Is Your Tang Weak?

Dear Windy,
 Para 5-62.b. of TM 55-1520-210-23-1 makes it clear: "Do not use any device other than the work aid described to spread the housing ears during trunnion removal/installation."

NEW WORK AID DEVICE

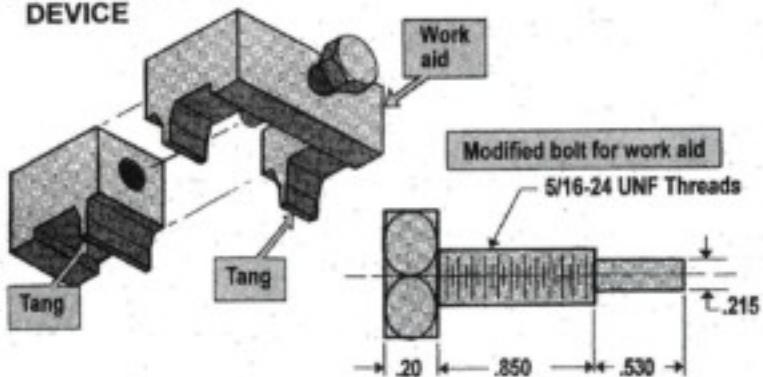
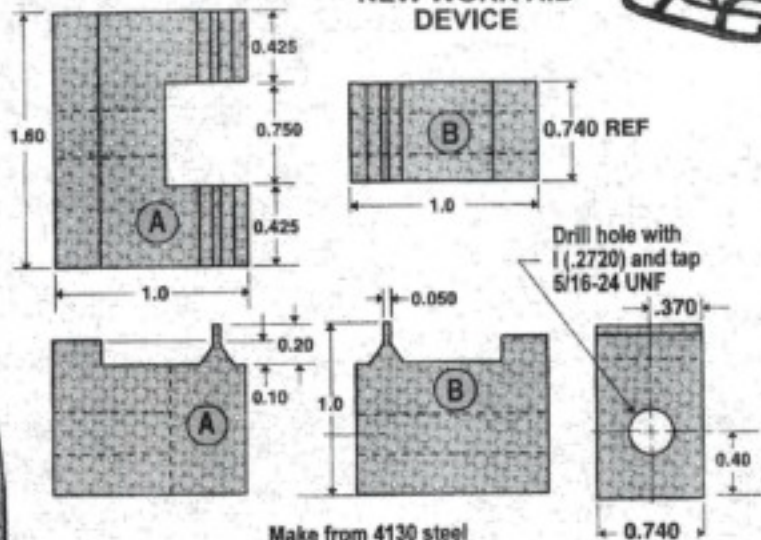
But the work aid described in Fig 5-38 has two tang problems. First, the tang where it fits in the trunnion is too thin. It bends, and in some cases, breaks. When that happens, you damage the swashplate trunnion.

Second, the tangs are not equal in surface area. There's an inch pulling against a half-inch.

Here's my solution to both problems:

If possible use bolt 5306-00-059-9283
 P/N 114D3053-7

Make from 4130 steel
